P68 SERIES

SERVICE BULLETIN

No. 75 Rev. 3

Subject: Flight Control Cables

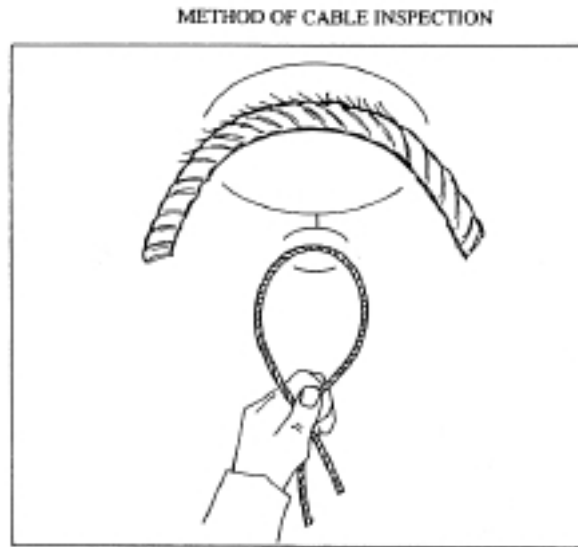
1. Remove locking wires from turnbuckles of each control cable.
2. Loosen and, if necessary, disconnect control cables from turnbuckles.
3. With reference to the following figure, bend the cable and visually inspect that it is free from defects, such as fraying, wear excess, corrosions, etc. in proximity of areas engaged by pulleys.

4. In case of defects ascertained (see also Service Instruction n° 33), replace the control cable with reference to Maintenance Manual.
5. In case of defect absence, restore control cable operating conditions with reference to Maintenance Manual.
6. Record the occurred application of this bulletins in the aircraft logbook.
